Technical Bulletin

TB5000-071

PF700 Variable Speed Drive Braking Resistors (Electrical) - Bodymaker

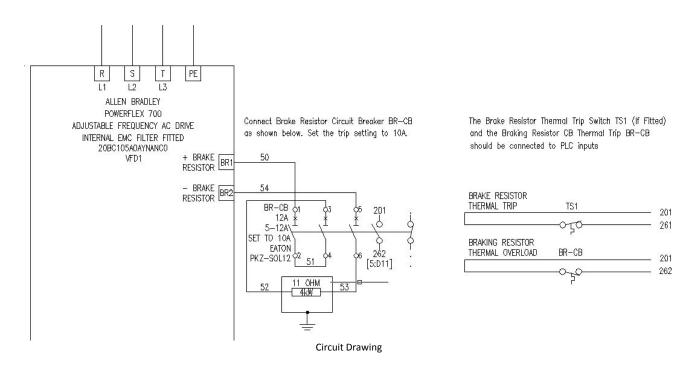
Summary: <u>Bodymaker main drive failure</u> After separate isolated incidents of electrical fires occurring with the resistor enclosures on the Bodymaker control panels, it has been decided to introduce a new DC circuit breaker (Eaton Moeller CB PKZ-SOL12) to protect the circuit and to also physically disconnect all power from the Bodymaker main drive to the resistors under fault conditions. Also, an auxiliary contact has been added which is connected to the PLC input, this removes the 'drive enable' and 'run' signals (see circuit drawing below).

The issue occurs when the fault current is generated on Braking Resistor terminals BR1 and BR2 due to a faulty PF700. The braking resistors are not physically disconnected from the source of the fault by the overload protection device, which in turn, leads to the potentially high DC currents.

The modified circuit (Eaton Moeller CB PKZ-SOL12) has been rigorously tested under fault conditions. Results confirm that the correct electrical protection of the braking resistors has been achieved.

CarnaudMetalBox Ltd strongly recommend that this Technical Bulletin be implemented across all 5000 Bodymakers affected by this electrical issue. Please contact your sales <u>representative</u> for further information.
